Access Compliance Report

Public Rights-of-Way

(Curb Ramps)

Intersection ID: N/A	Main Street: MINTVALE_DR	Cross Street: PALUSTRIS_CT	Location: N
ADA ID: BB96226E35EA	Ramp Type: Perp	Initial Pass/Fail: Fail	Overall Compliance: No
Codes/Mitigation Info/Possible Solution		Field Measurements/Component Compliance	
Severity Score: 31.25

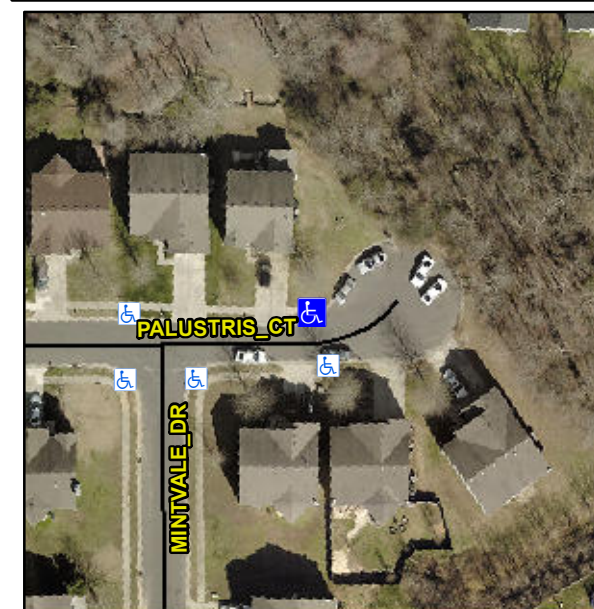
Not Found, R304.5.1, R304.2.2, R304.5.3

Compliance	Description	Data	Compliance	Description	Data
N/A	Ramp Length (in)	48.0	No	Ramp Slope (%)	9.1
No	Ramp Width (in)	33.0	No	Ramp XSlope (%)	4.6
N/A	Flare Type LT	N/A	N/A	Flare Type RT	N/A
N/A	Flare Slope LT (%)	N/A	N/A	Flare Slope RT (%)	N/A
N/A	Flare Traversable LT?	N/A	N/A	Flare Traversable RT?	N/A
N/A	Landing Length (in)	N/A	N/A	DWS Provided?	N/A
N/A	Landing Width (in)	N/A	N/A	DWS Contrast?	N/A
N/A	Landing Slope (%)	N/A	N/A	DWS Length (in)	N/A
N/A	Landing X Slope (%)	N/A	N/A	DWS Full Width?	N/A
N/A	Landing Curb? (Y/N)	N/A	N/A	DWS Offset (in)	N/A
N/A	Shared Landing?	N/A			
N/A	Gutter Ponding?	N/A	N/A	Gutter Slope (%)	N/A
N/A	Gutter Lip Ht (in)	N/A	N/A	Gutter X Slope (%)	N/A
N/A	Painted X Walk1?	No	N/A	Painted X Walk2?	N/A
	X Walk 1 Direction	To S		X Walk 2 Direction	N/A
N/A	X Walk 1 Width (in)	N/A	N/A	X Walk 2 Width (in)	N/A
	X Walk 1 Slope (%)	0.7		X Walk 2 Slope (%)	N/A
	X Walk 1 X Slope (%)	0.4		X Walk 2 X Slope (%)	N/A

Remove & Replace Entire Ramp.
